# Memorandum to the City of Markham Committee of Adjustment

**File:** A/15/19  
**Address:** 5 Balsam Street, Markham  
**Applicant:** Mrs. Shahla Rasheed & Mr. Ghulam Mustafa  
**Agent:** HNS ENGINEERING INC  
**Hearing Date:** Wednesday May 08, 2019

**PROJECT: SECOND SUITE CONVERSION w/BELOW GRADE ENTRANCE**  
5 Balsam St Markham, ON L6B 0J7

PROPOSED LOT PLAN

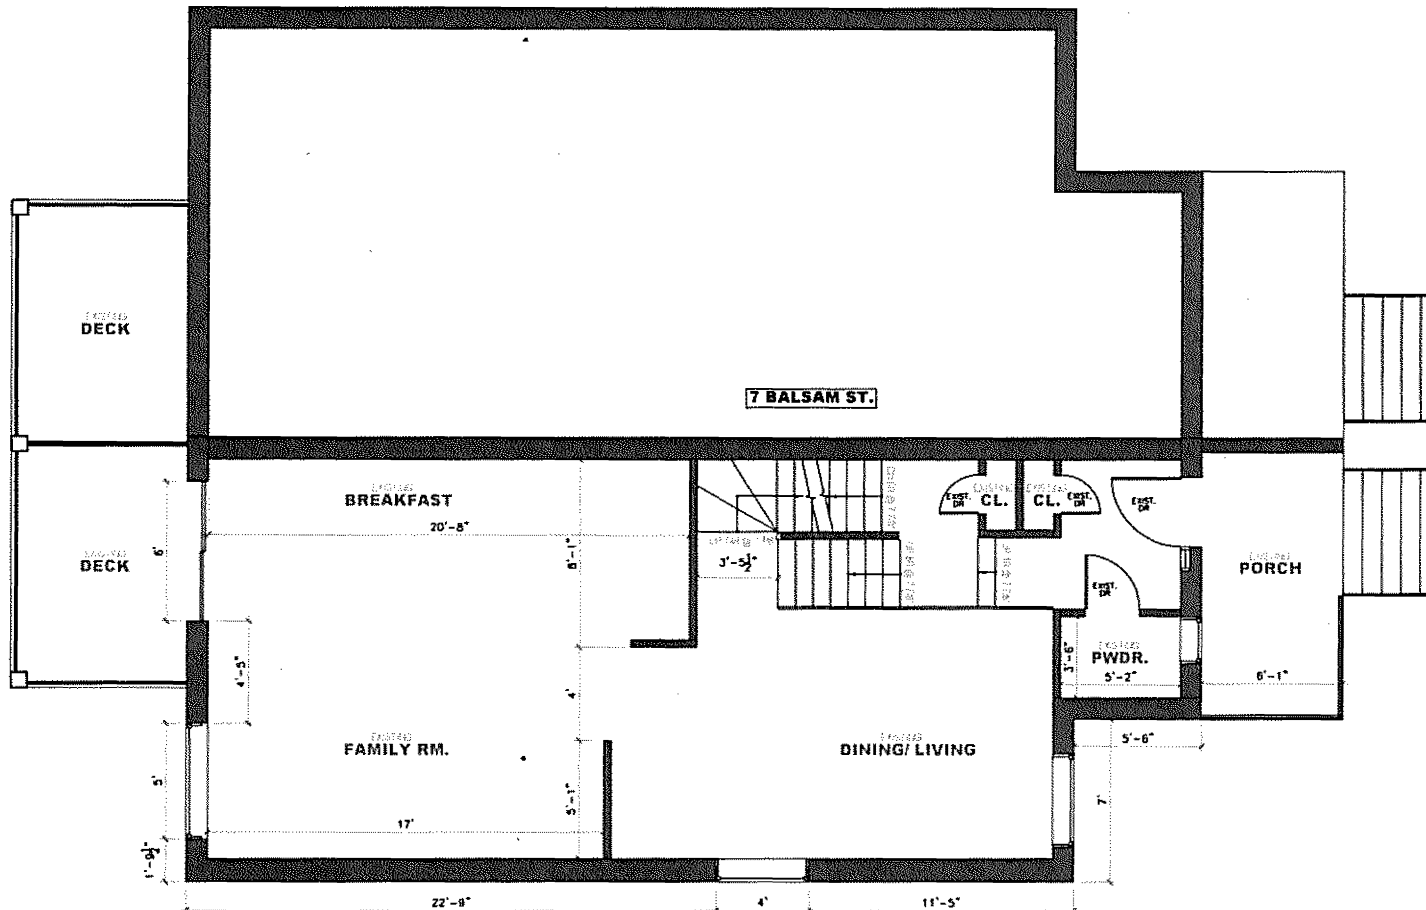
As shown in Appendix B, the rear lane adjacent to the subject property intersects with another public lane along the north side yard of the site. This lane to lane intersection creates a curved rear lot line which limits the potential of adding a parking pad that would comply with the minimum width requirements of Parking Standards By-law 28-97, as amended. An extended driveway at this location could pose safety concerns with respect to site lines at the lane to lane intersection. Further, requiring an additional parking space will result in changes to the subject property that reduce soft landscaping in the rear yard. Soft landscaping plays an important part of good storm water management practice by reducing the amount of soft surface area that provides for the infiltration of rain water. Staff do not have concerns with the requested variance to reduce parking for the accessory dwelling unit.
